State Significant Development Modification (MOD 1)

Port Kembla Bulk Liquids Terminal
(SSD 7264)

TQ Document Number: PJ-PK-0001---REPT-025

21 November 2016

Development Staging Plan (MOD1)

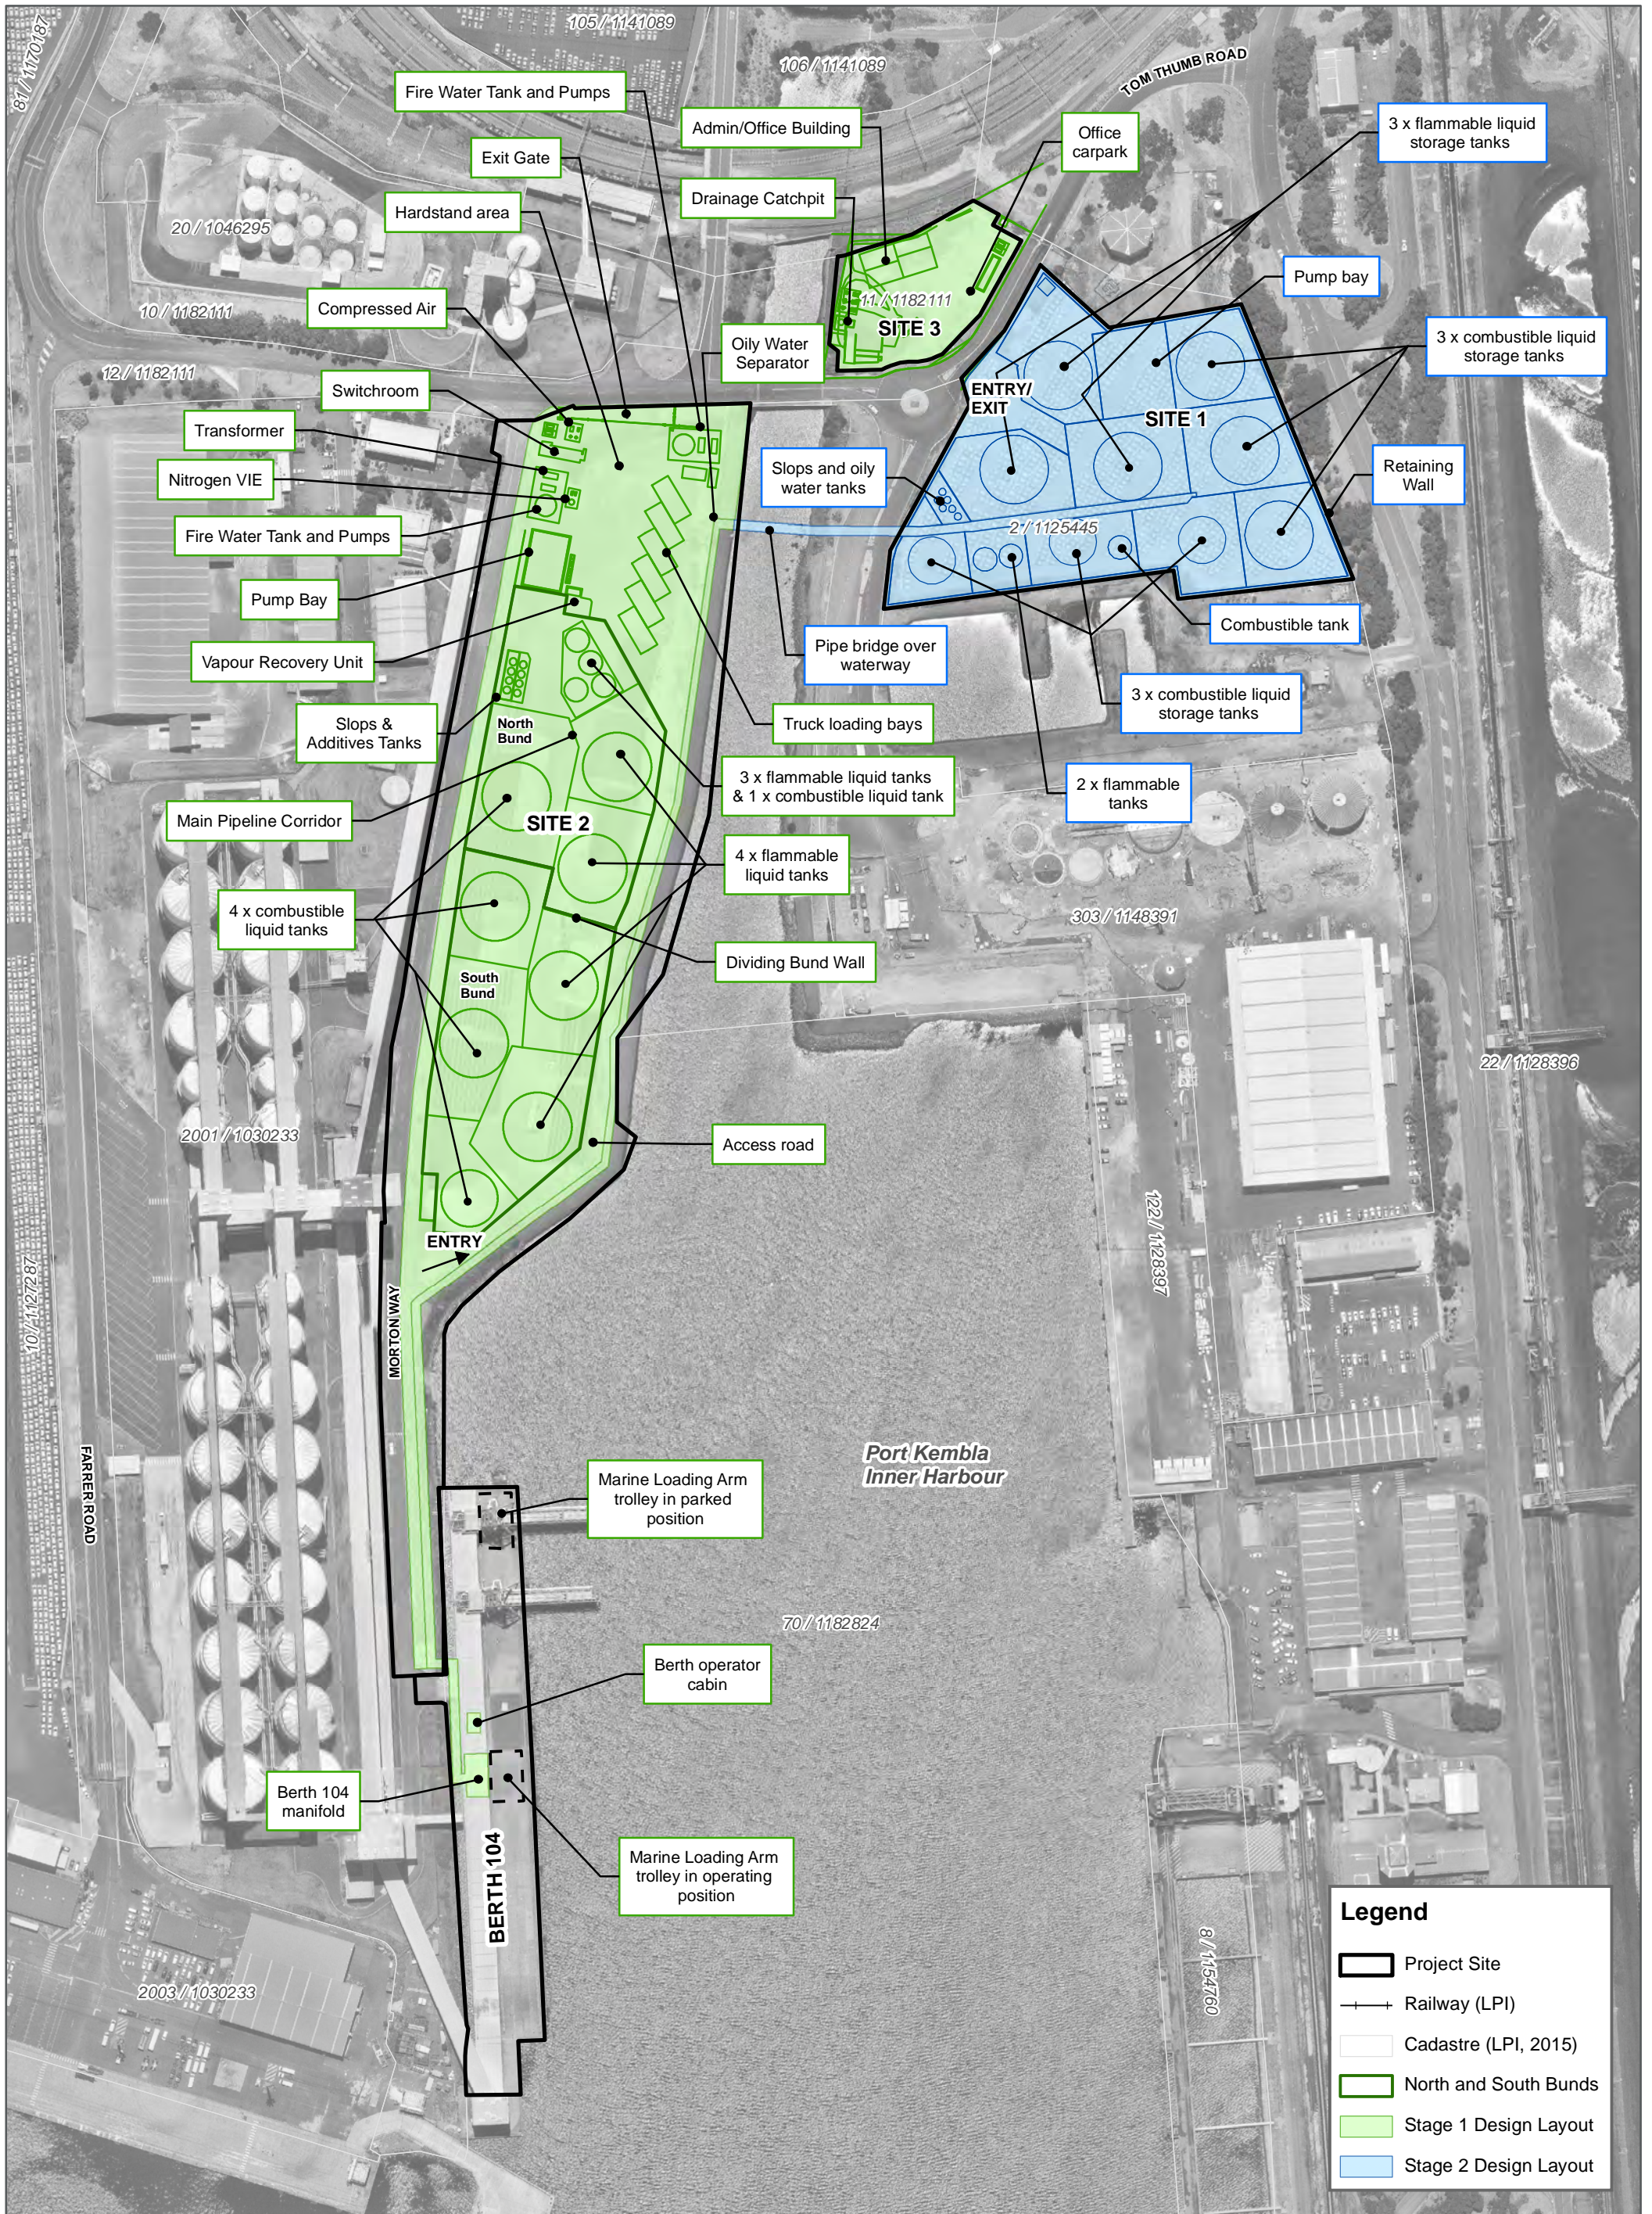
7	Relocation of oil separator from Site 3 to Site 2.	Oil separator located on Site 3. See Figure 3-3 of the EIS (Cardno, 2015a).	Oil separator located to Site 2. See Figure 2-1 .
8	Relocation of additive and slops tanks within Site 2.	See Appendix C of the EIS (Cardno, 2015a) for design layout.	See Appendix A for design layout. See Figure 2-1 .
9	Minor adjustment to bulk storage tank locations. Including replacing one 18ML tank with two 1.5ML tanks.	See Appendix C of the EIS (Cardno, 2015a) for design layout.	See Appendix A for design layout. See Figure 2-1 .
10	Minor Truck loading bay realignment.	See Appendix C of the EIS (Cardno, 2015a) for design layout.	See Appendix A for design layout. See Figure 2-1 .

11	Relocation of the pump bay within Site 2.	See Appendix C of the EIS (Cardno, 2015a) for design layout.	See Appendix A for design layout. See Figure 2-1 .
12	Relocation of Nitrogen vacuum insulated evaporator (VIE) from Site 3 to Site 2.	See Appendix C of the EIS (Cardno, 2015a) for design layout.	See Appendix A for design layout. See Figure 2-1 .
13	Relocation of Air Compressors from Site 3 to Site 2.	See Appendix C of the EIS (Cardno, 2015a) for design layout.	See Appendix A for design layout. See Figure 2-1 .

The proposed dimensions and locations of the tanks are included in **Table 2-6**. See **Figure 2-1** for an outline of the proposed changes in relation to the overall site layout.

The site layout has been amended as per the minor modifications described in **Section 2** and shown on **Figure 2-1** to ensure firefighting security, reduce overall hazard and risk propagation off site and to ensure that operational efficiencies can be attained.

Stormwater Management During Construction and Operation

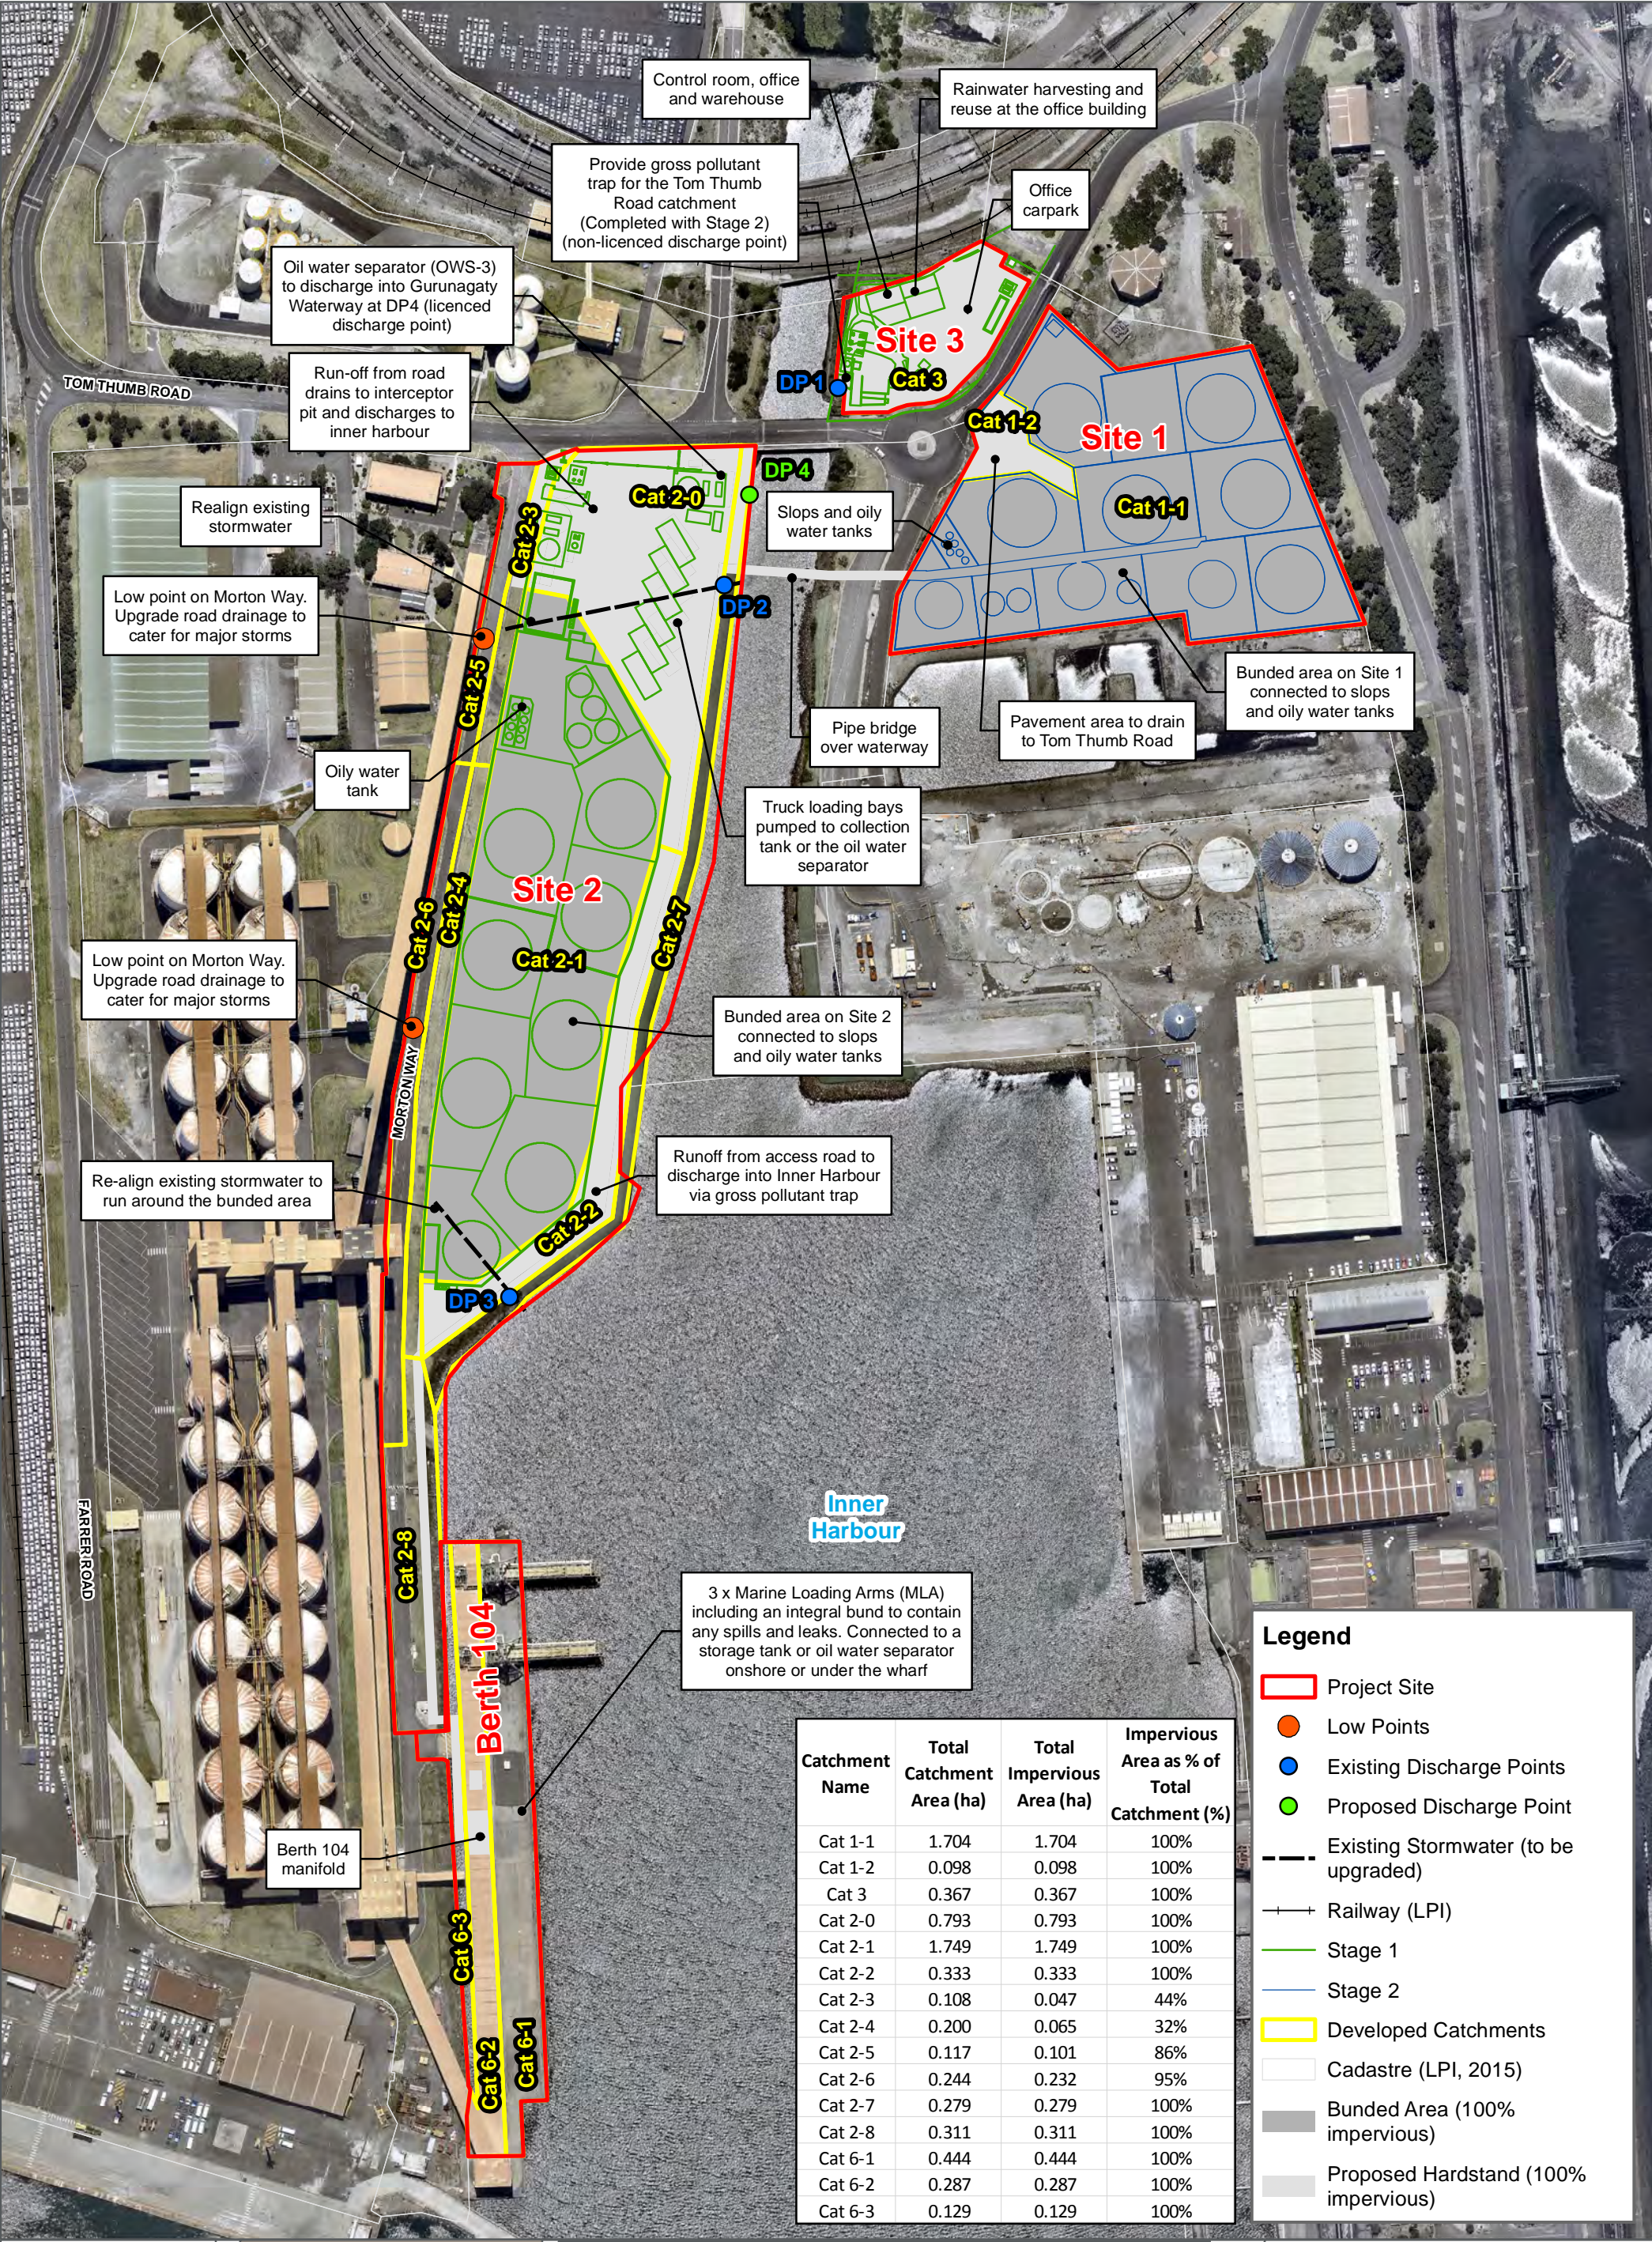
The Surface Water Assessment (Cardno, 2015e) was reviewed by Cardno to assess the impact of the proposed modifications on hydrology, flooding, water quality, water supply and wastewater. A revised Stormwater Management Plan (**Figure 5-1**) was developed in line with the proposed layout and design for the site.

Although the proposal seeks to increase the bund height from 1.8m to 3.9m, the development footprint and bund area remain unchanged and the proposed modification will not result in changes to the site hydrology, flood extent or discharge.

- > Retention of the existing sediment basin on Site 3 during construction (Stage 1).
- > Replacement of the sediment basin with a GPT unit during Stage 2. The location, design and layout of the GPT will occur in accordance with the approved development (SSD 15_7264) as outlined in the Surface Water Assessment (Cardno, 2015e). As noted in the Surface Water Assessment in the EIS, the discharge point from the GPT is not a licensed discharge point as it caters for the road catchment only.
- > Relocation of the OWS from Site 3 to Site 2 with the licensed discharge point moved to Site 2. Transfer and treatment of stormwater discharge from Site 1 at Site 2.
